PROJECT TITLE: Renovation To Hamden DMV
1985 State Street
Hamden, Connecticut

PROJECT NO.: BI-MM-41

SUBJECT: ADDENDUM # 1

BID OPENING	1:00 P.M.	February 10, 2010
ADDENDUM NUMBER 1	DATE OF ADDENDUM	February 1, 2010

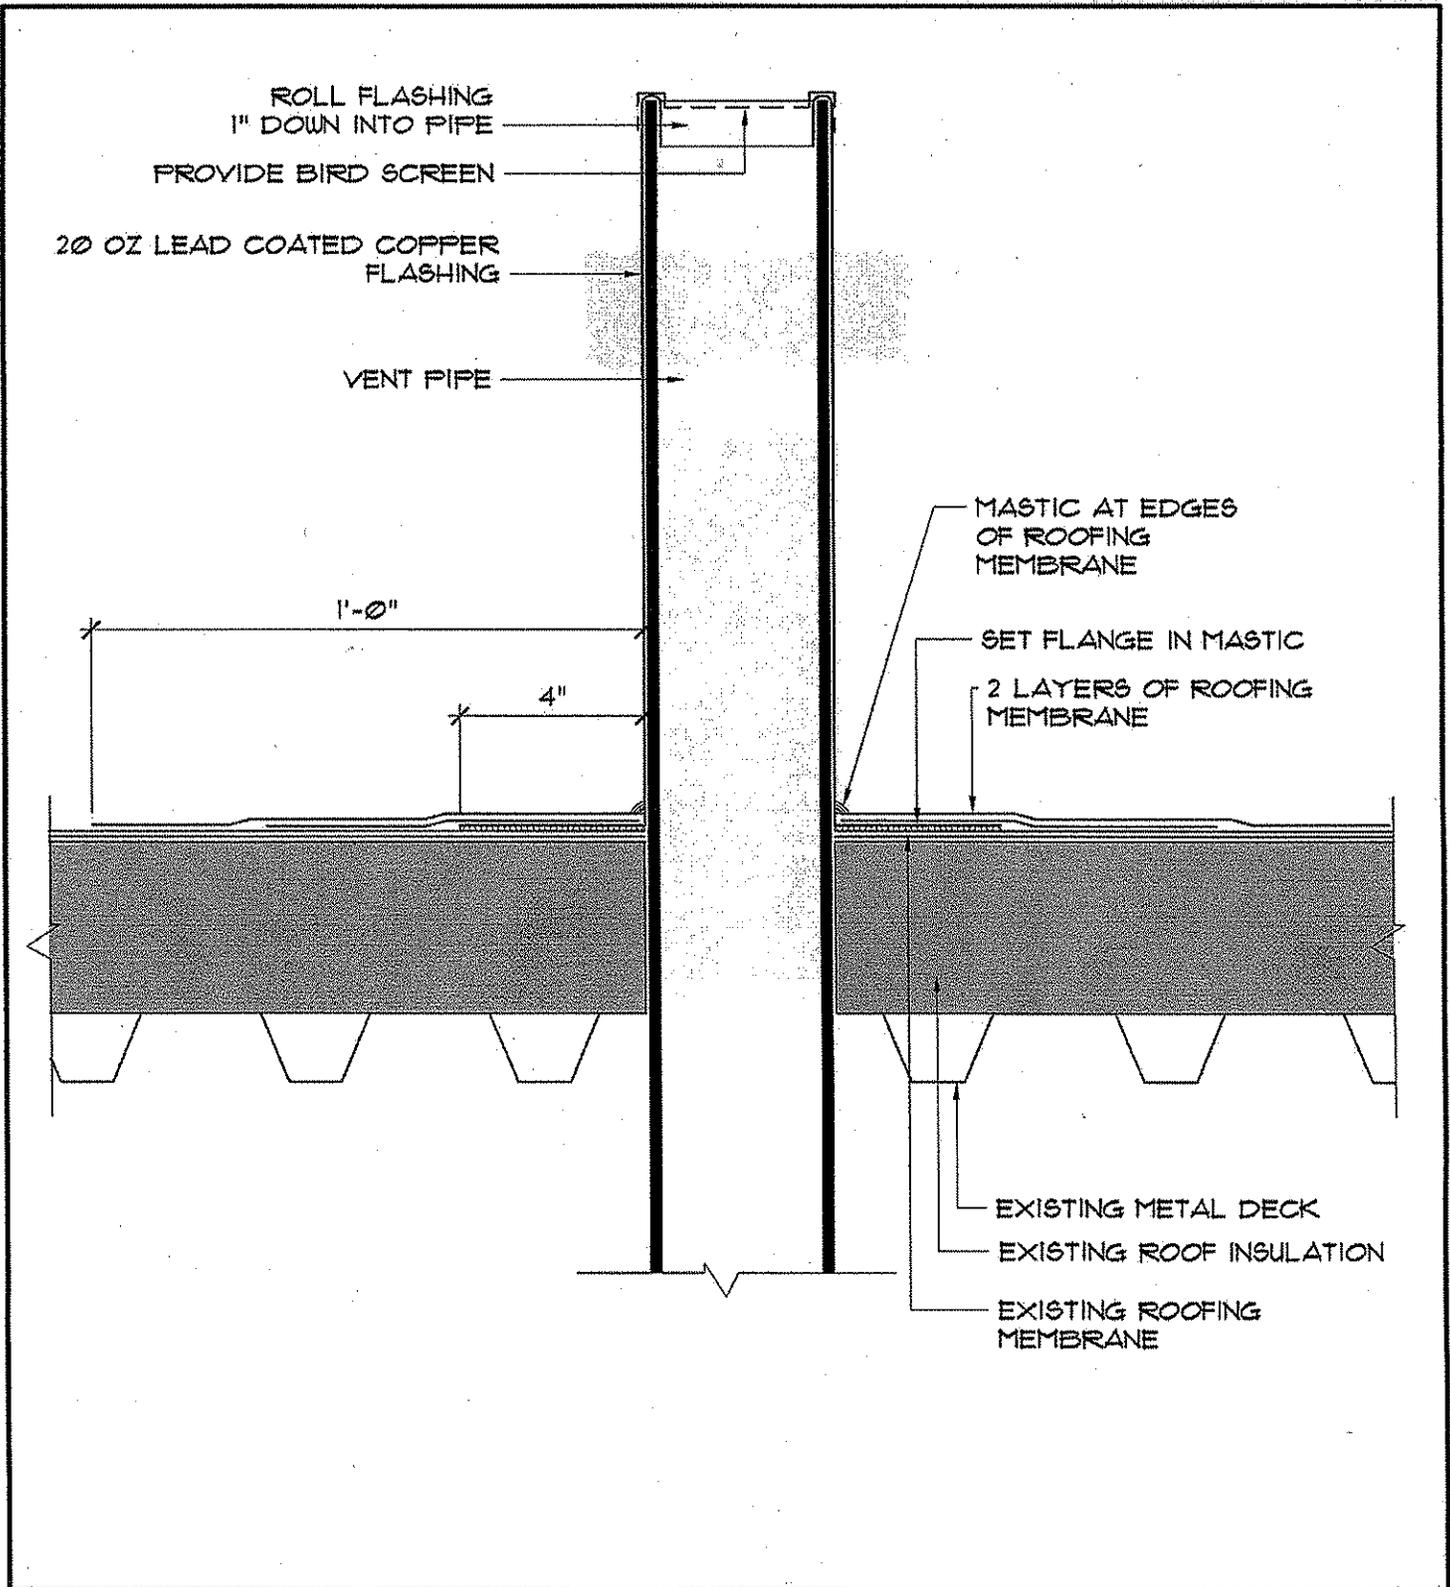
34- Simplex Grinnell requested to be an approved equal for the Fire Alarm System 283200.2.1.a+b.

Approved

DRAWING NO.
SK-A1
APPENDUM # 1
DATE: JAN 29, 10
SCALE: 3/4"=1'-0"

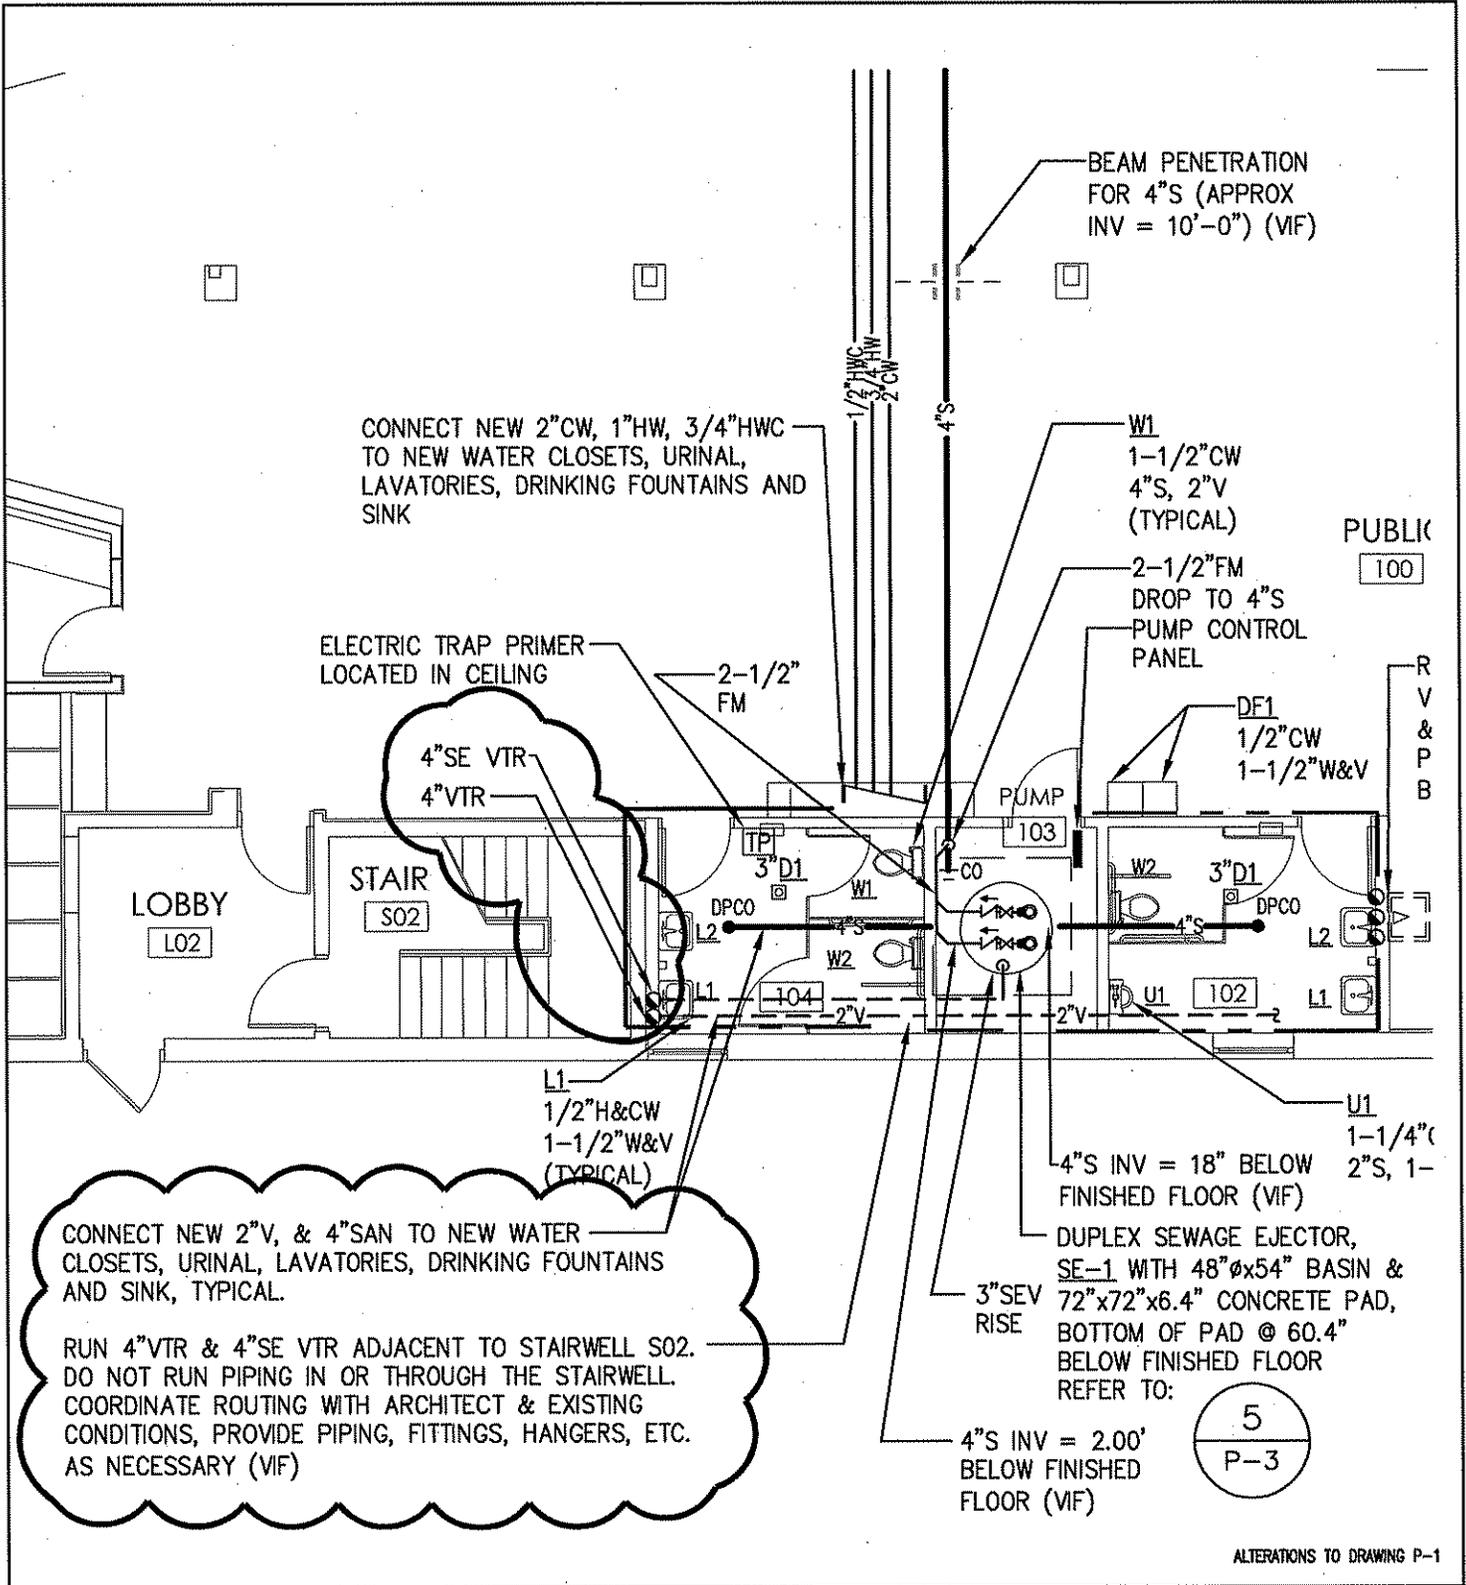
"4"SE VTR and 4" VTR are to rise up to the roof as tight against the existing wall of Stair S02 as possible. Core drill existing second floor concrete slab for the vent pipes. Space cores 12" apart to avoid requiring structural support. Fire sealant opening around pipes with UL designed 1 hour system. Cut opening in existing roof deck and roofing system for new vent pipes. Cut opening as small as possible to avoid requiring structural support. Provide flashing detail as shown on SK-A1, SKP-01 and SKP-01A attached."
